RE: **PETITION NO. 1487** – TRITEC Americas, LLC petition for a declaratory ruling, pursuant to Connecticut General Statutes §4-176 and §16-50k, for the proposed construction, maintenance and operation of a 1.97-megawatt AC solar photovoltaic electric generating facility located at 254 Putnam Road, Pomfret, Connecticut, and associated electrical interconnection.

**Petition No. 1487
TRITEC Americas, LLC
Pomfret, Connecticut
Interrogatories**

Attachment B: Revised Site Plan

SHEET TITLE:
**SEDIMENTATION & EROSION CONTROL PLAN
(2 OF 3)**

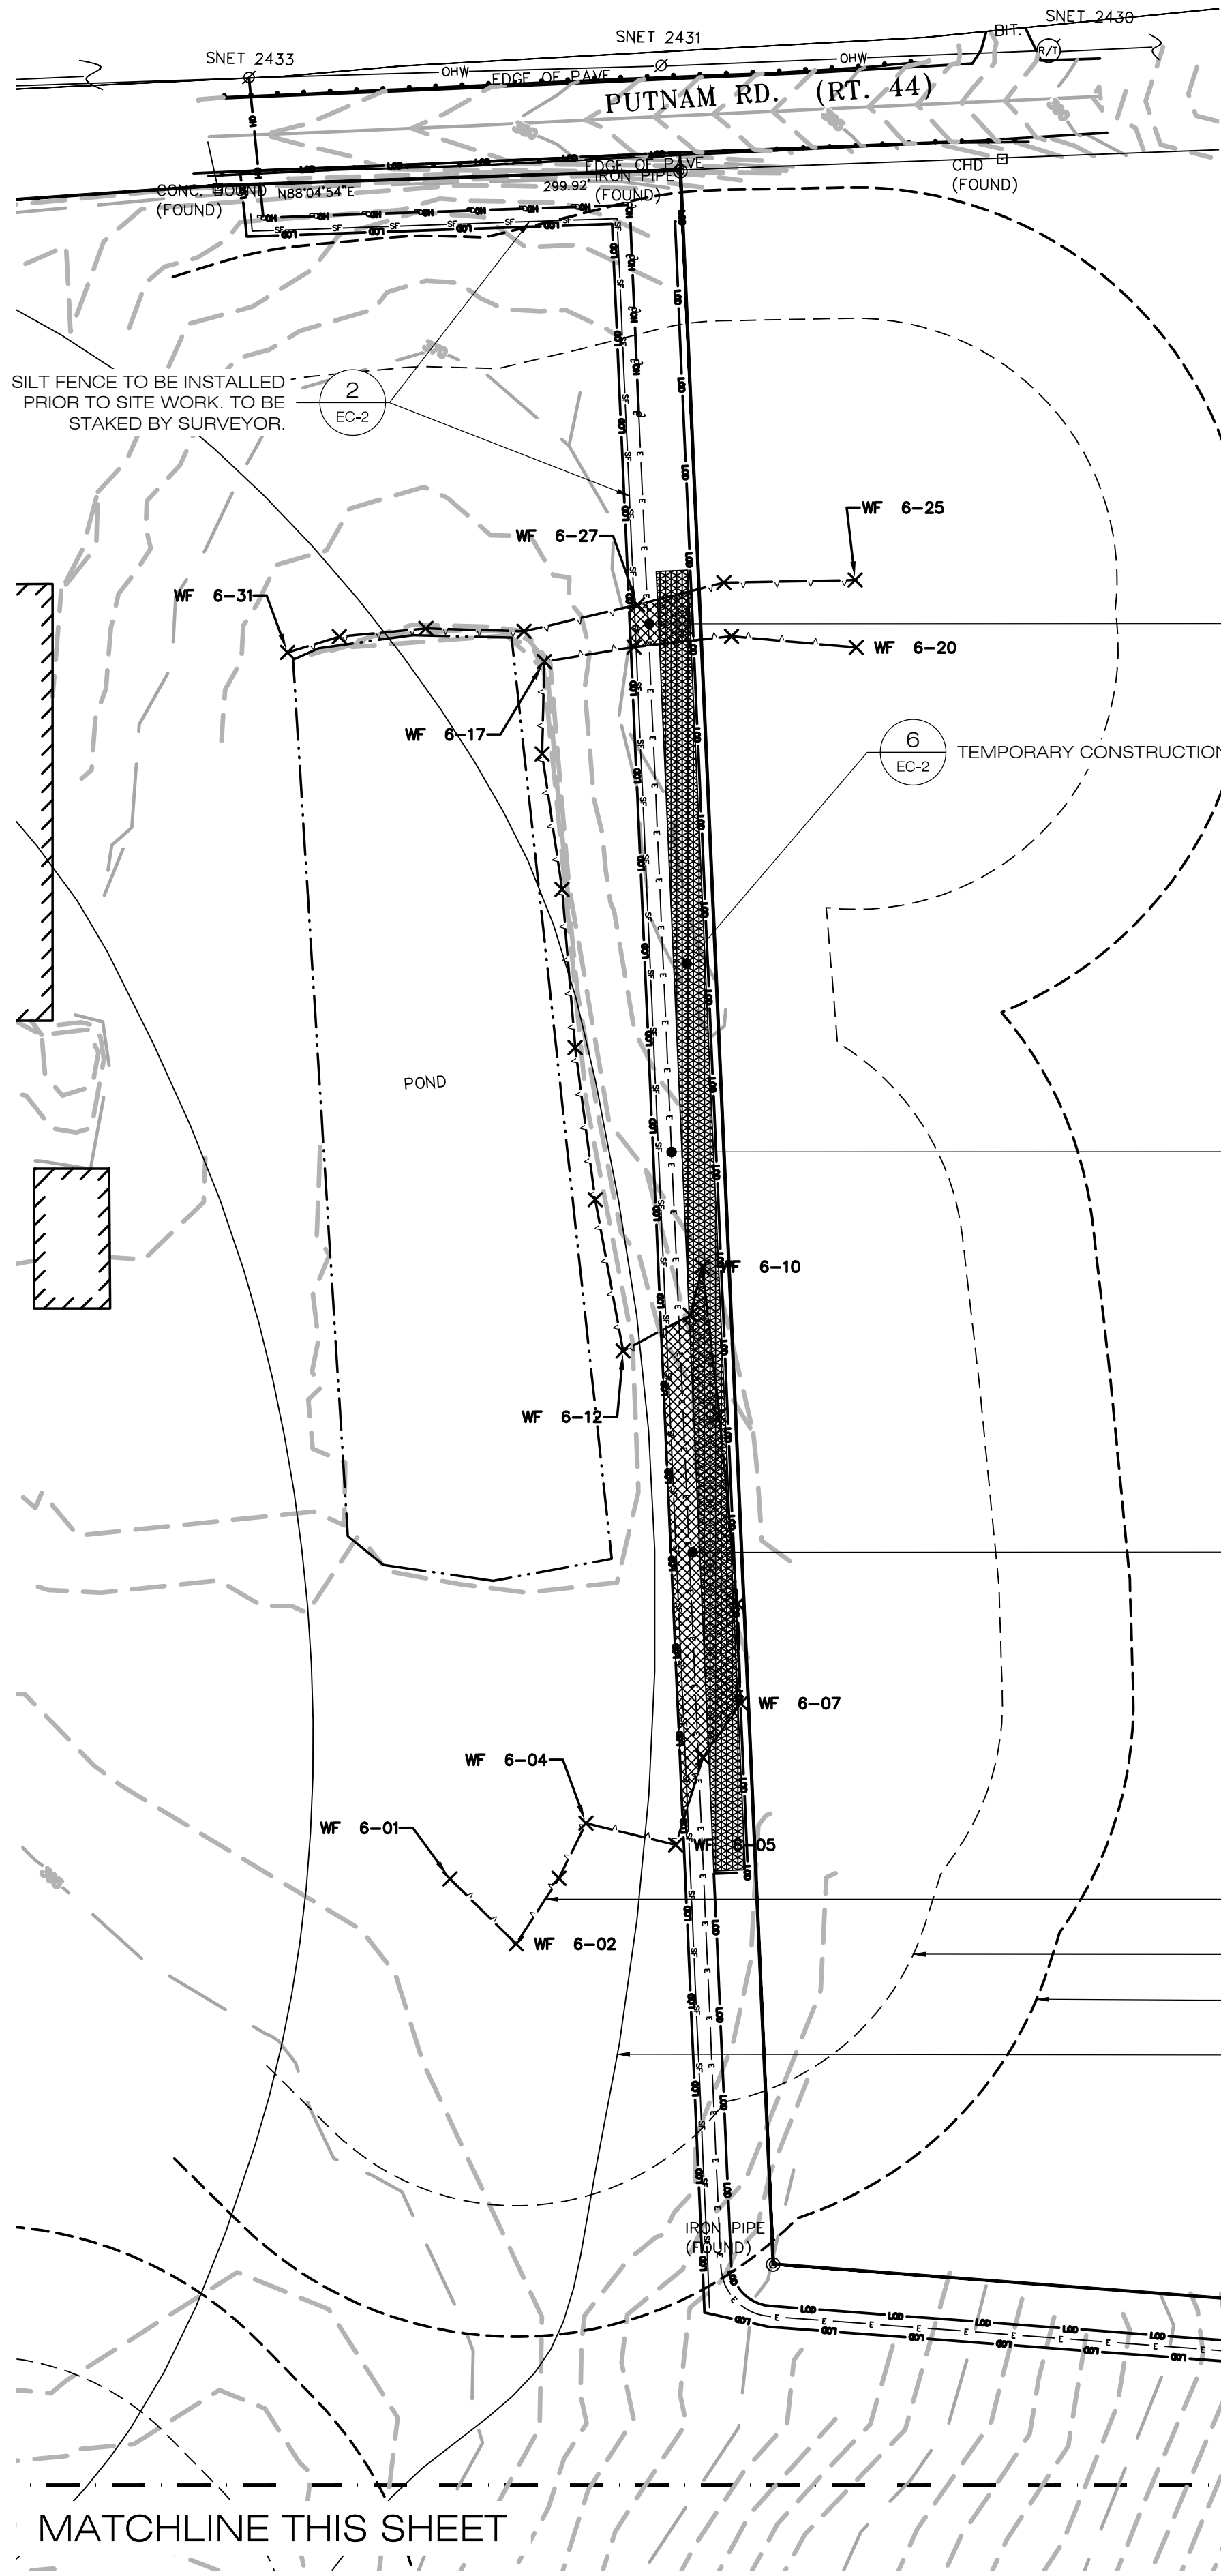
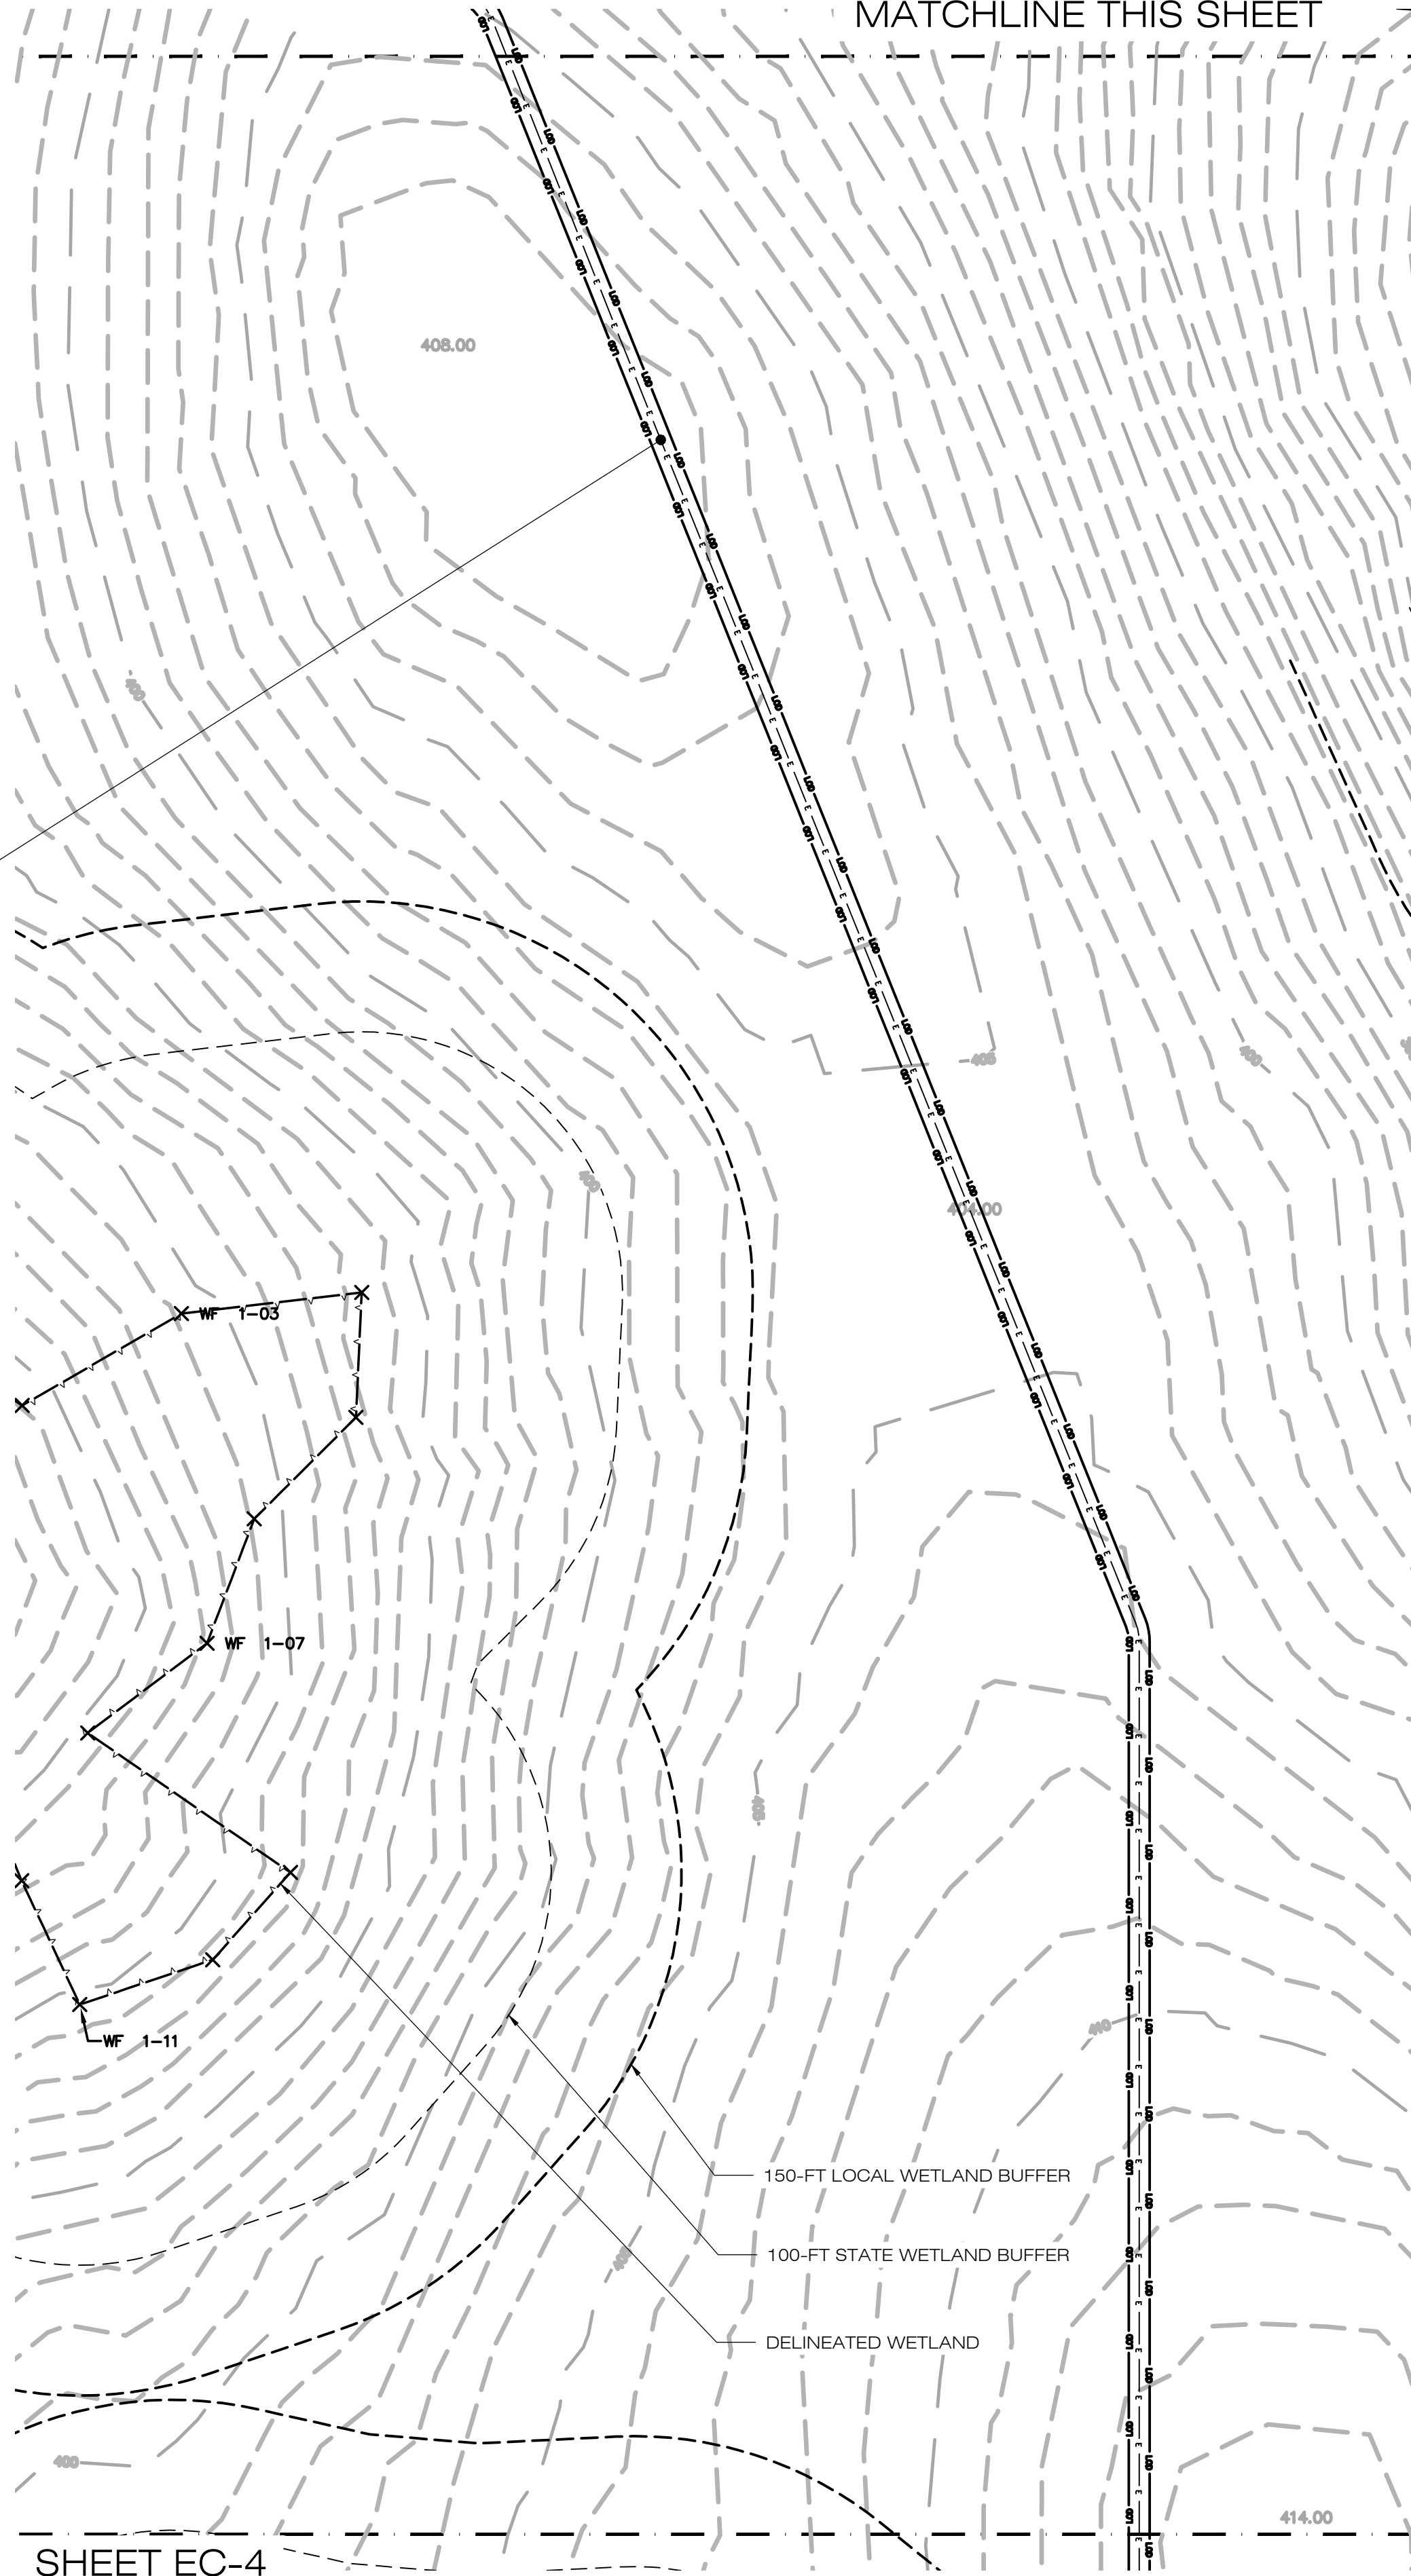
29. Referring to Site Plan EC-4, what is the purpose of the silt fence “arms” that extend east from the solar field footprint?

The purpose of the silt fence arms is to provide perimeter control for the drainage flowing southeast in this area. These “arms” are placed on contour to provide the most effective runoff and sediment capture potential for the project areas upstream.

7 **ERNST SEED MIXES**
SCALE : N.T.S.

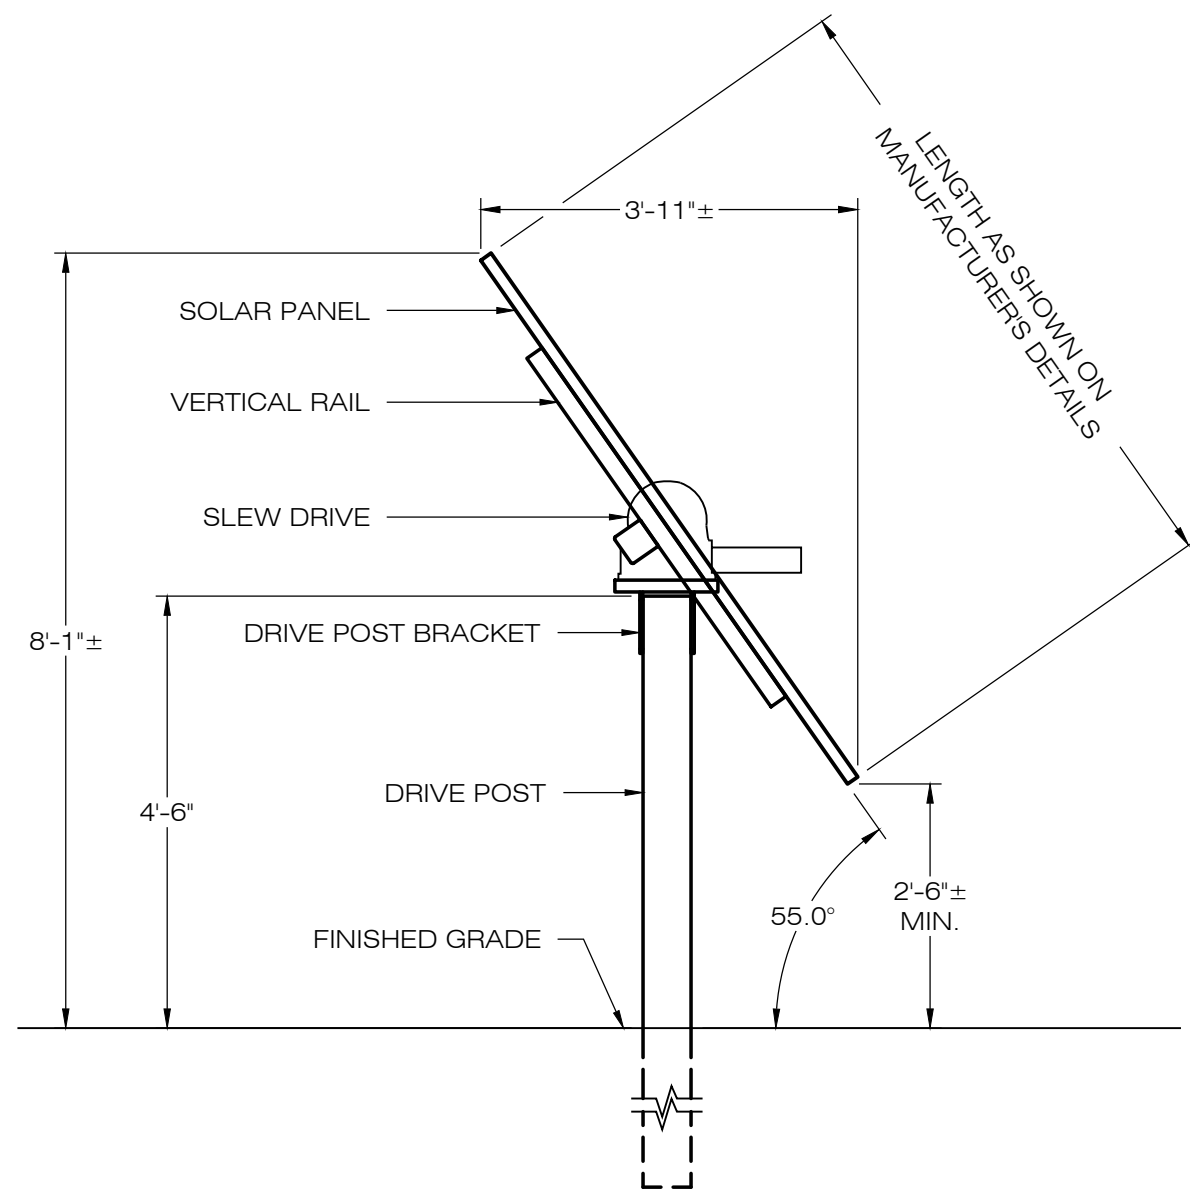
32. Referring to Site Plan DN-1, the selected solar field seed mix contains 95 percent lawn grass. Can a seed mix be used that contains more pollinator species? If no, why not? If yes, provide seed mix detail.
